ADDENDUM NO. 2

February 23, 2022

**DOUGLAS MACARTHUR ELEMENTARY SCHOOL ADDITIONS,
RENOVATIONS, AND RELATED WORK
Crown Point, IN 46307**

This Addendum consists of Pages ADD 2-1 through ADD 2-2 and attached Addendum No. 2 from Gibraltar Design dated February 21, 2022 and consisting of 7 pages, Specification Section 12 25 00 - Roller Shades and 52 drawings.

WALL SECTION
SCALE: 3/4" = 1'-0"

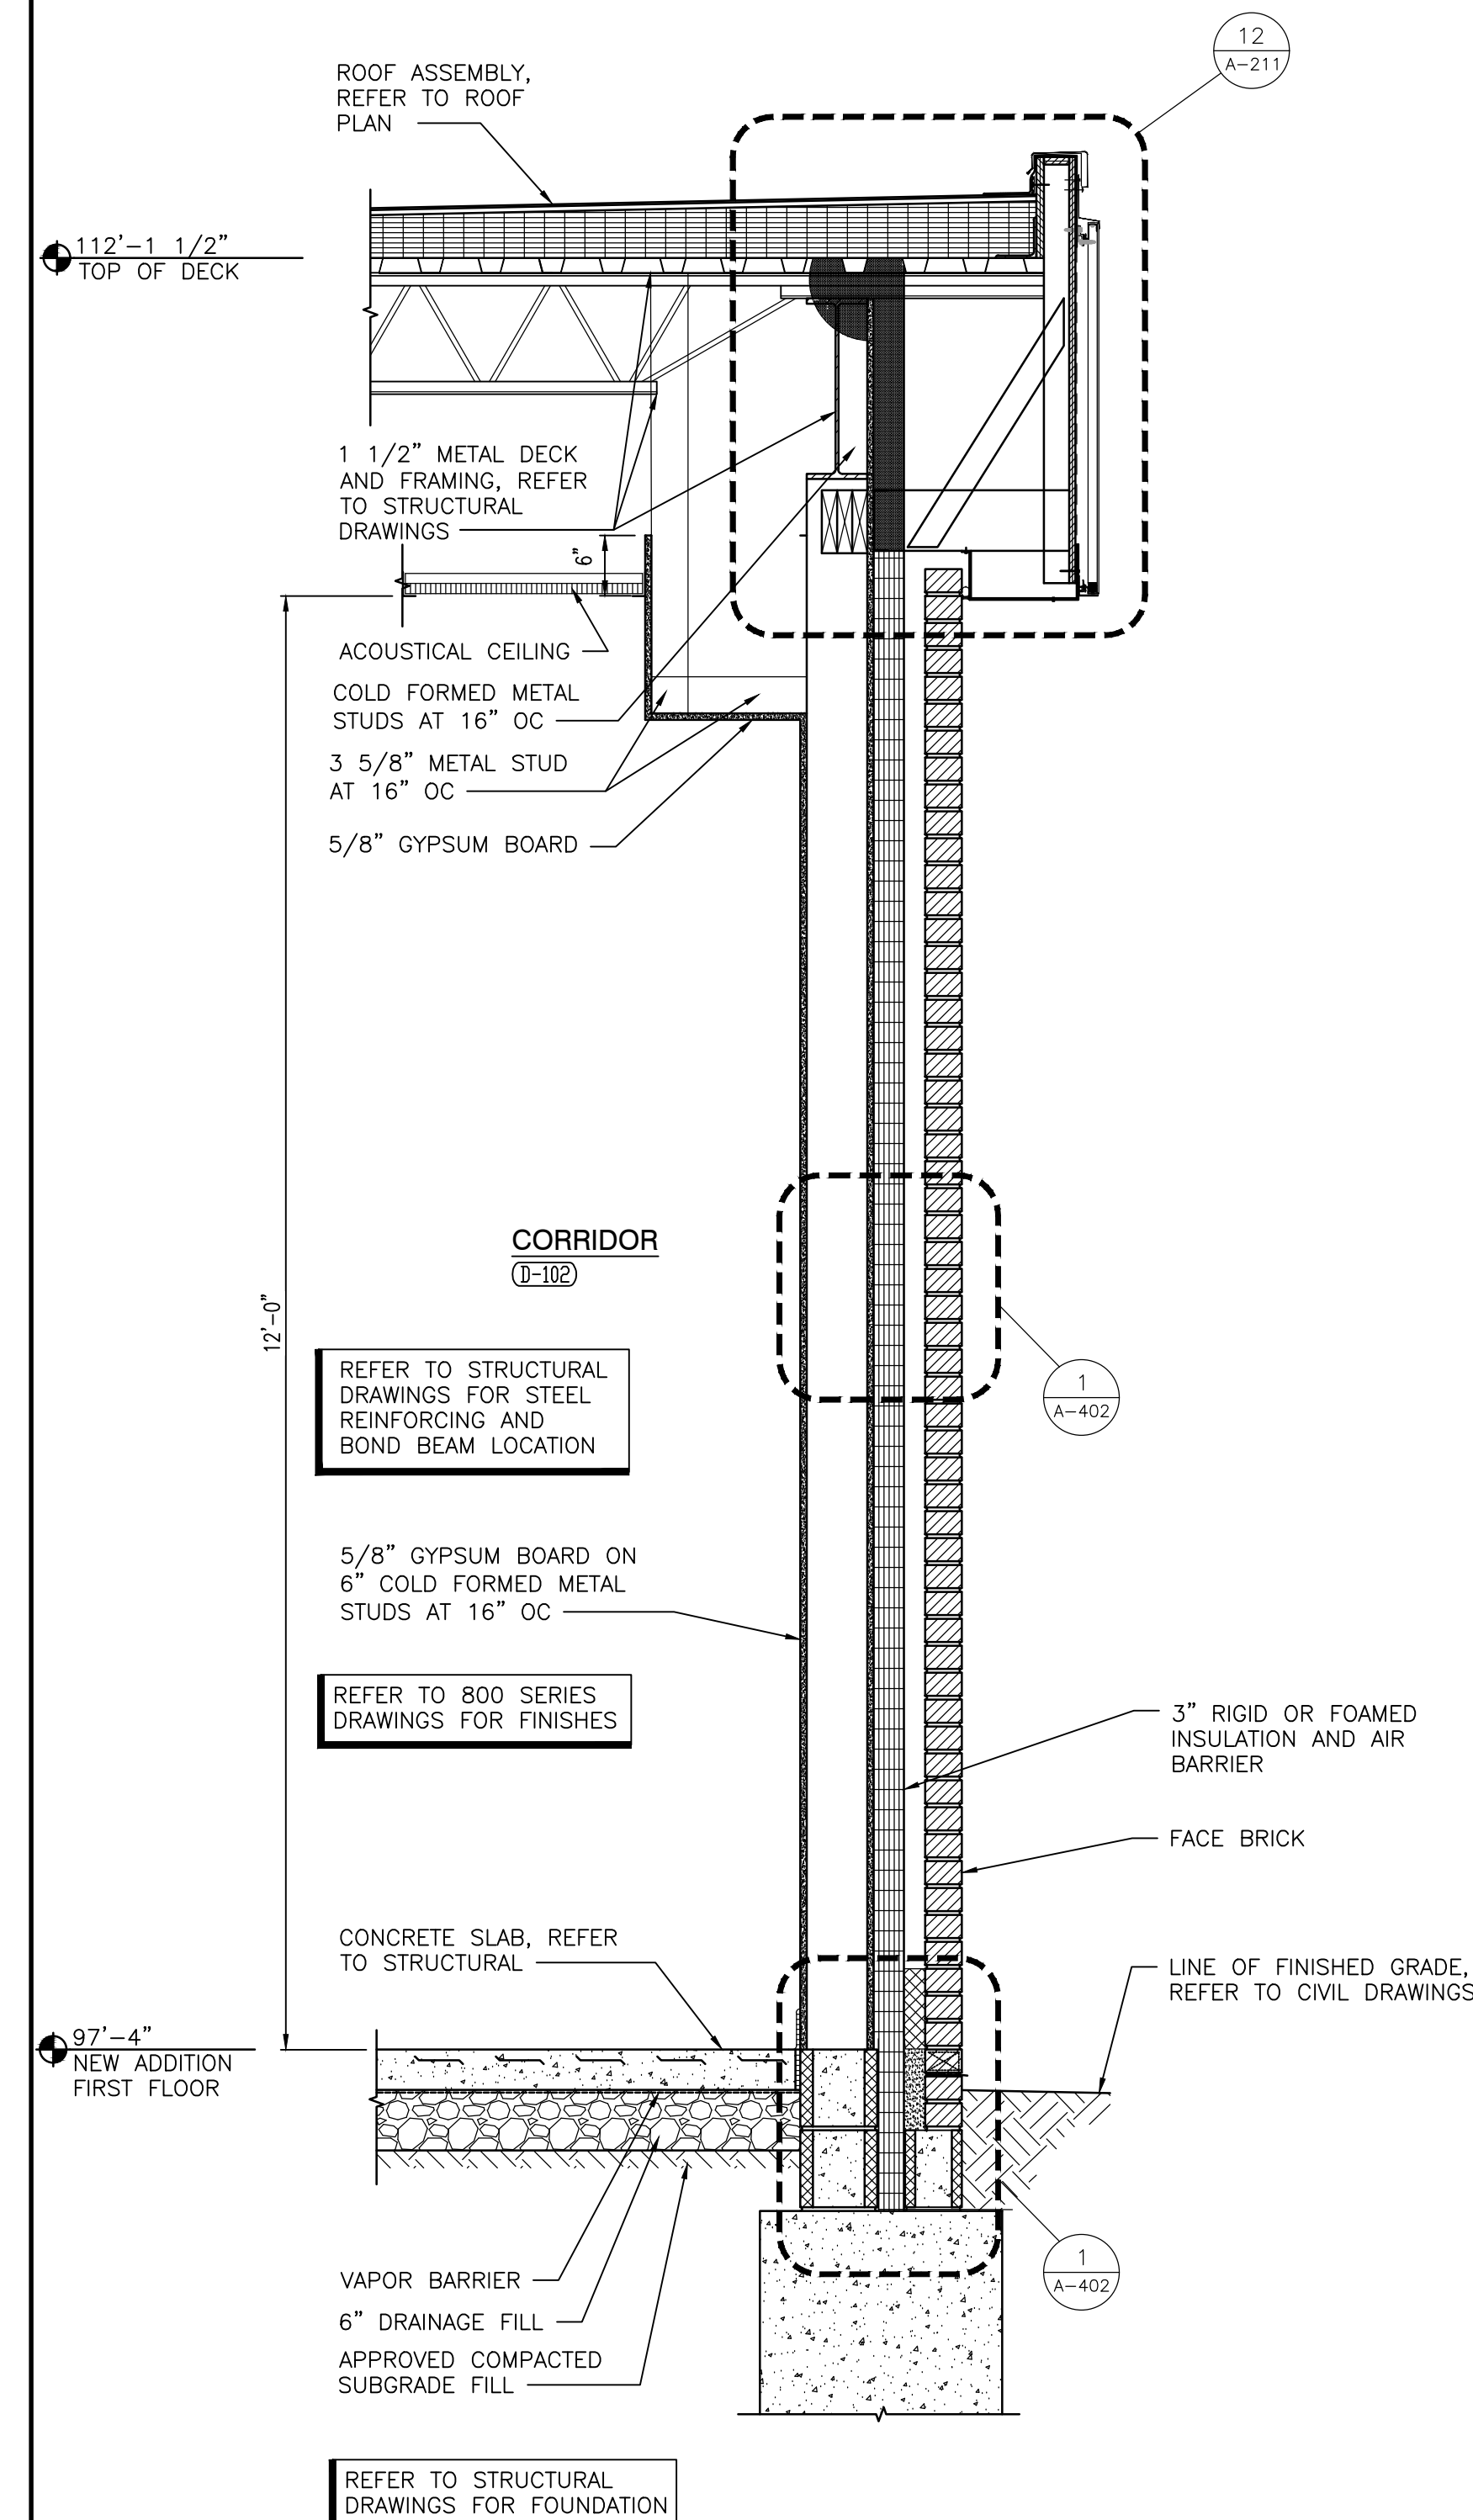
- A. Refer to revised, full size drawing, included in this Addendum, for the following revisions:
 - 1. Revise Reference bubble on 2/A-408
 - 2. Revise Wall section 4/A-408 with the two plan details to be 5/A-408 and update notes.

A-420

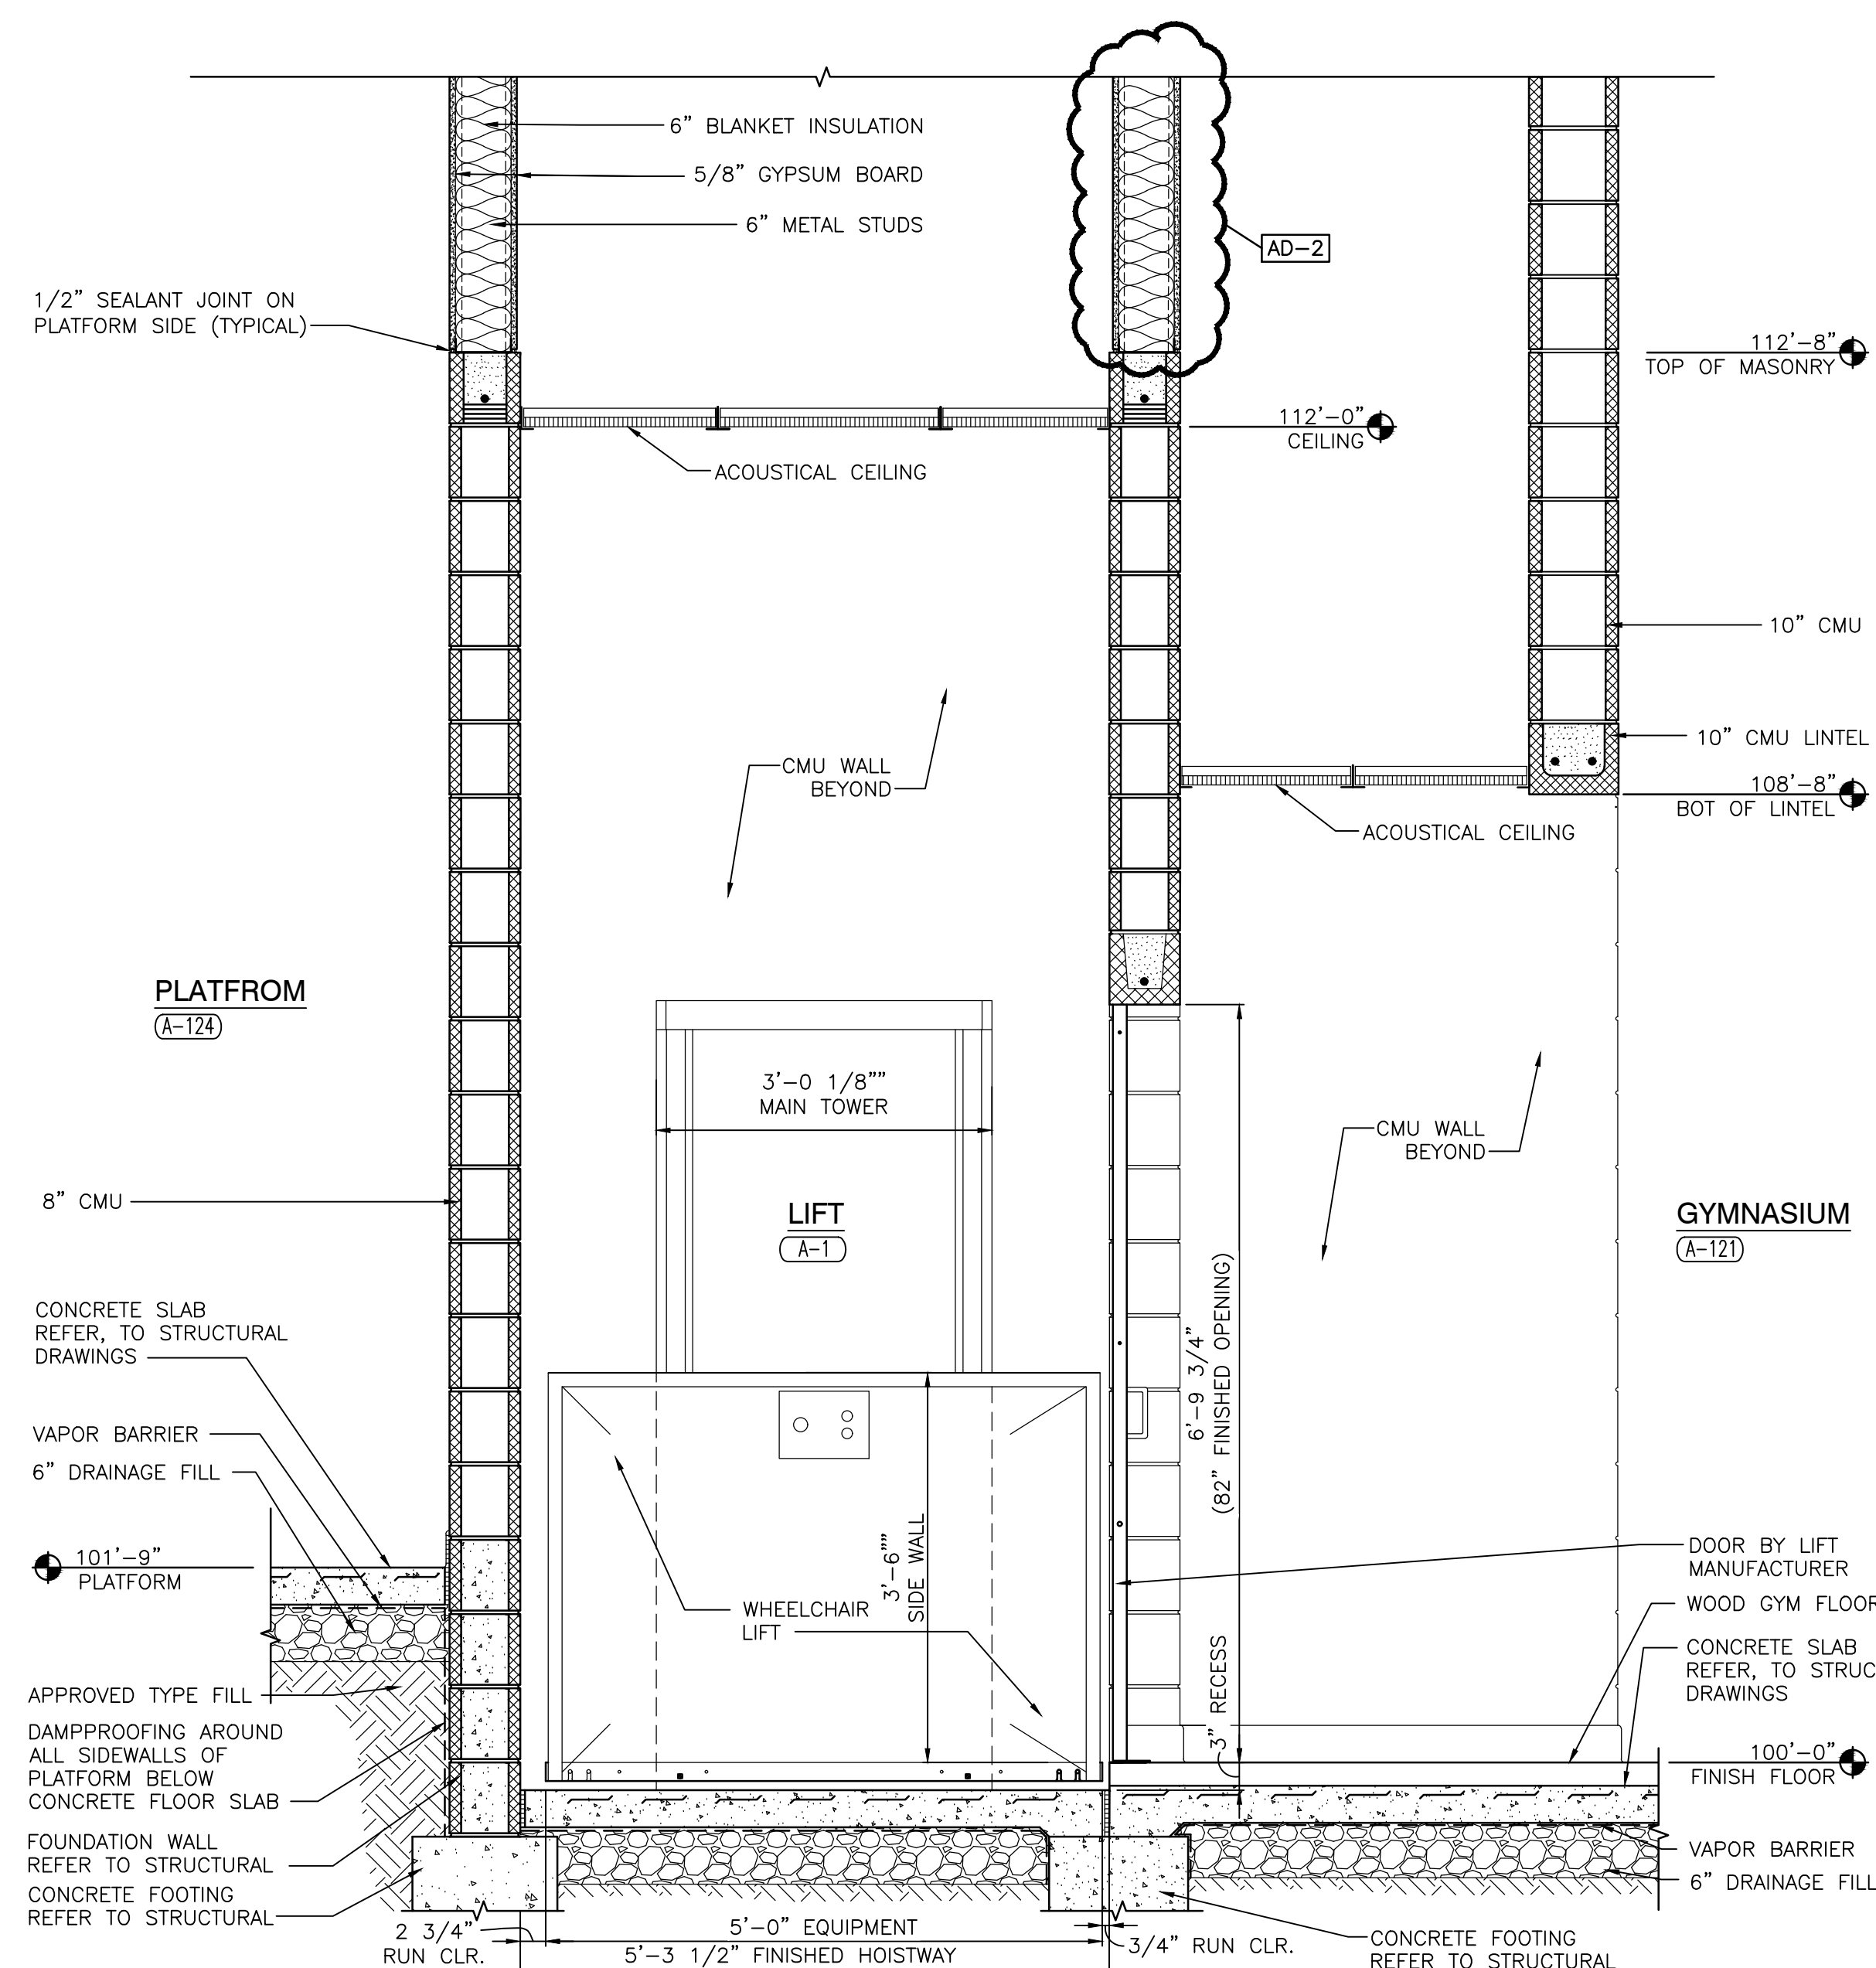
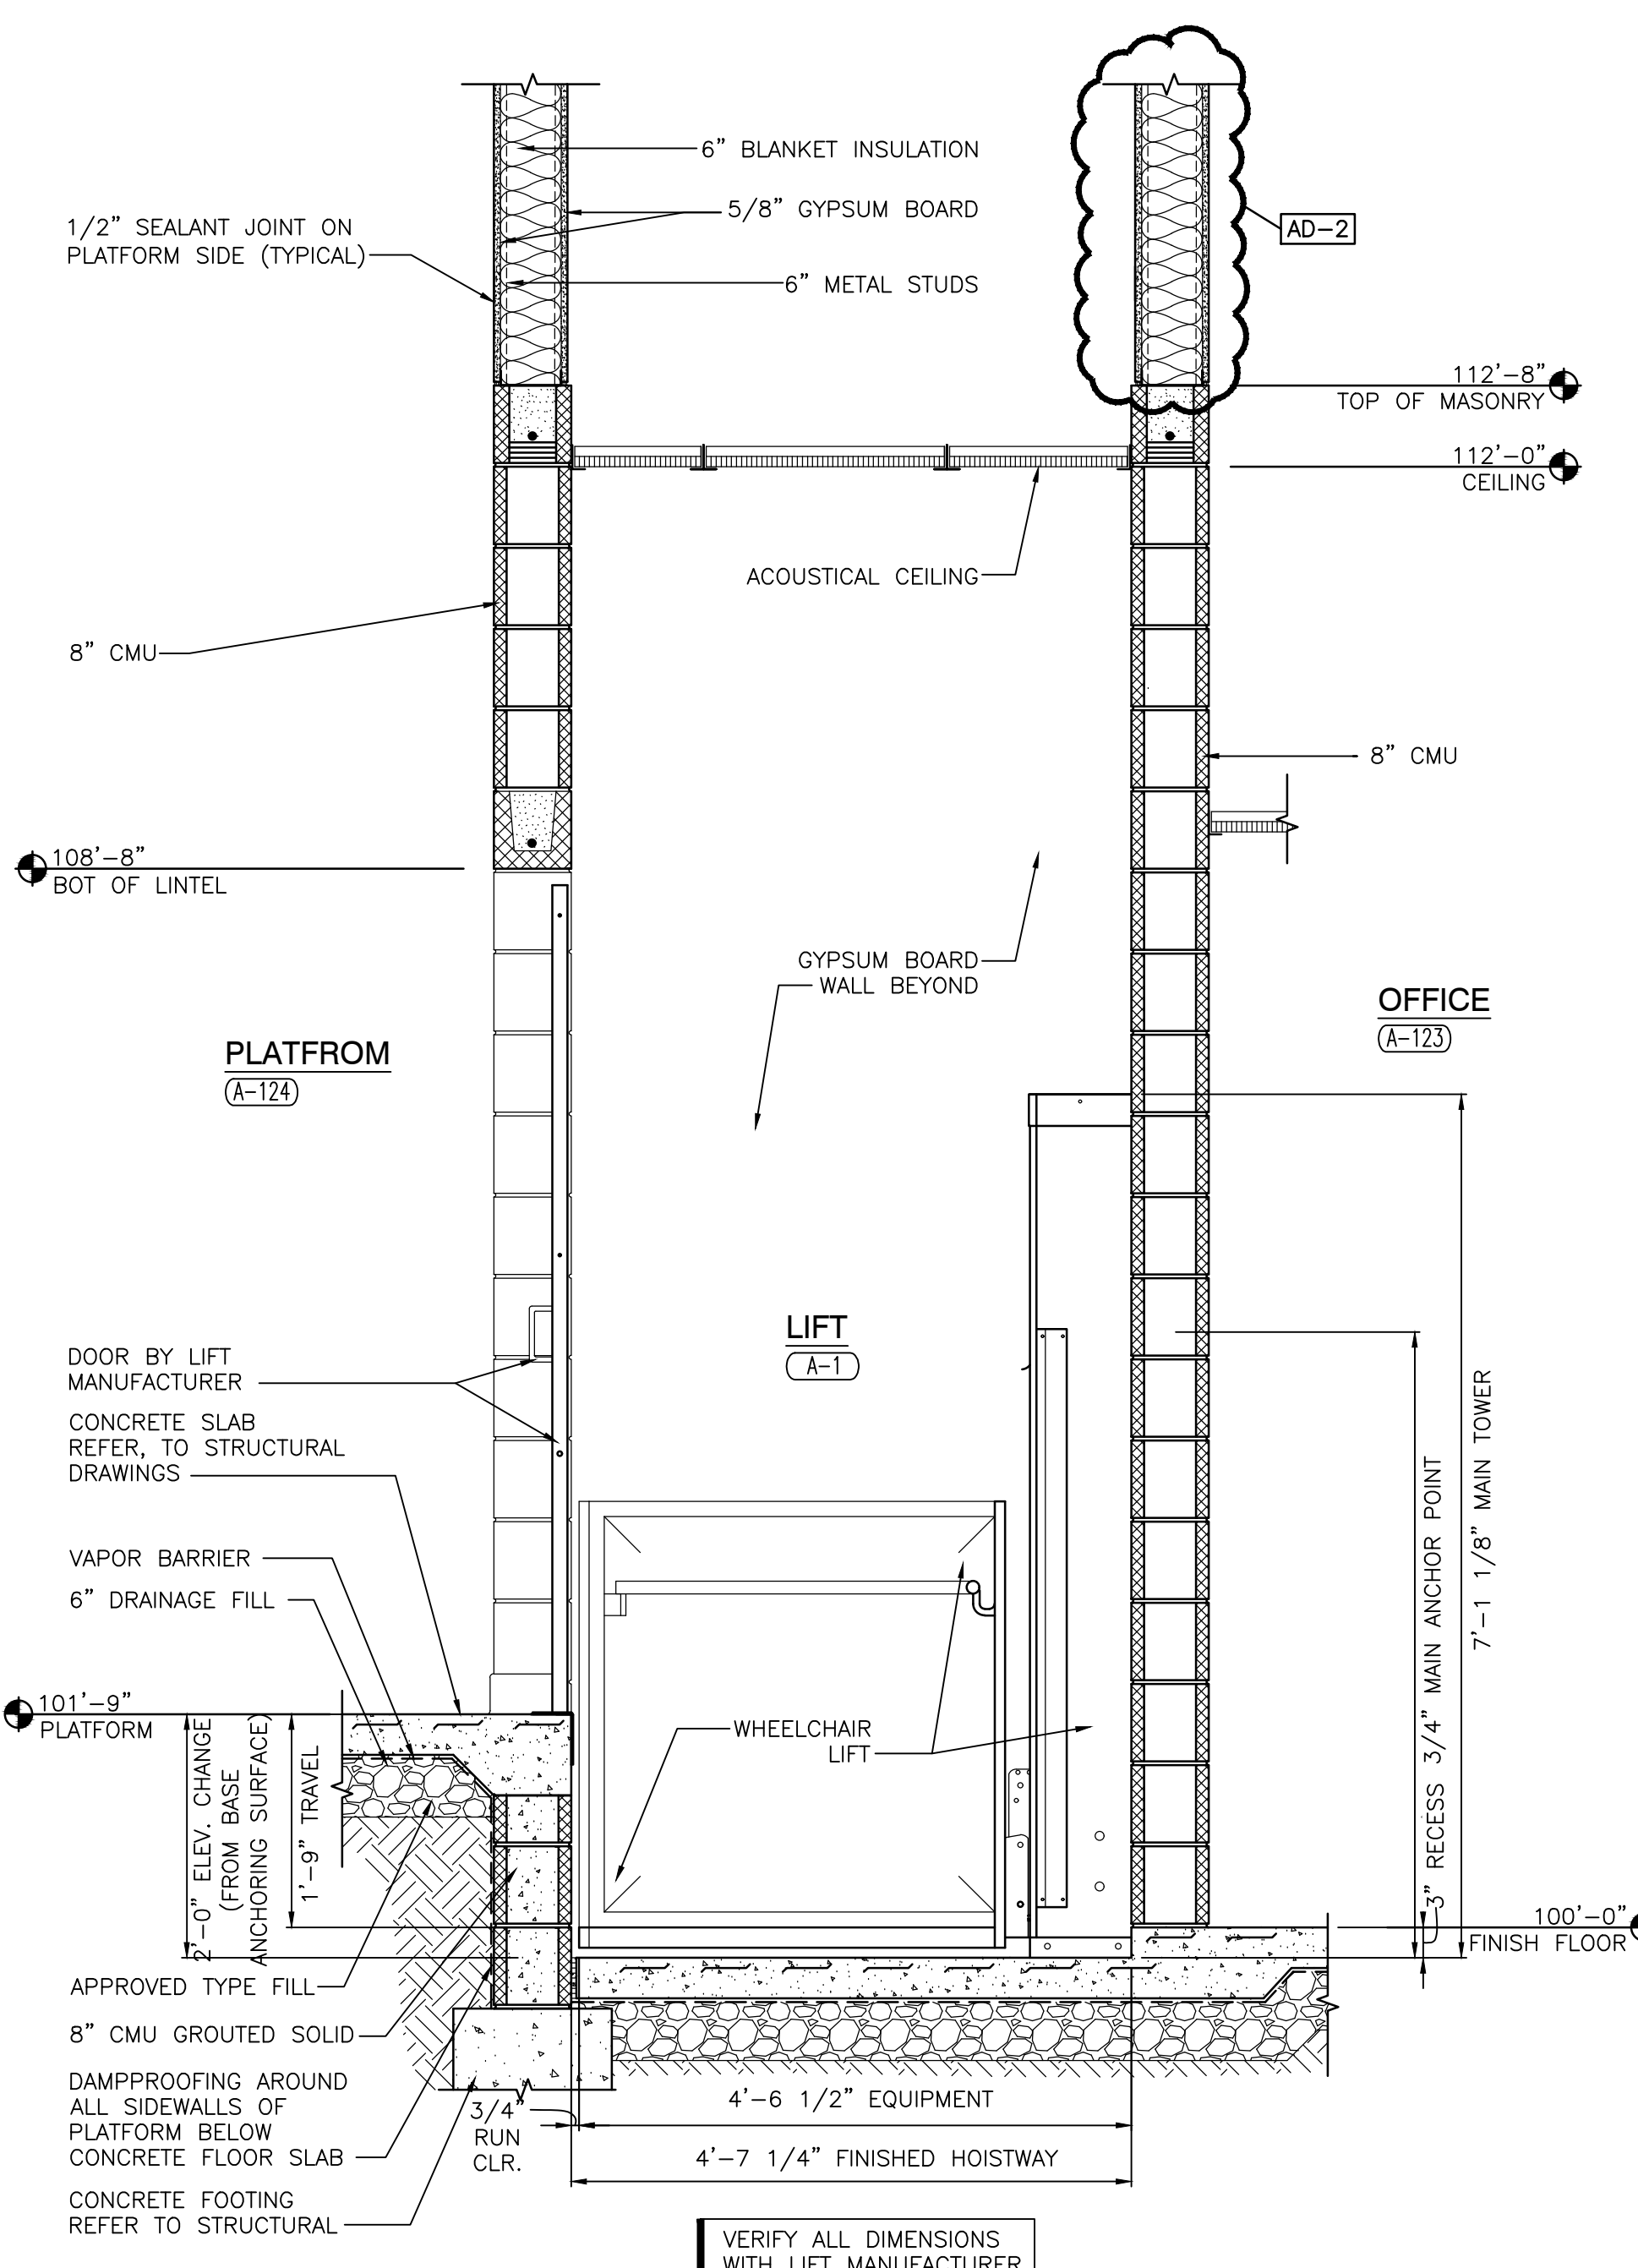
- A. Refer to revised, full size drawing, included in this Addendum, for the following revisions:
 - 1. Revise Wheelchair Lift Sections 1/A-420 and 3/A-420.
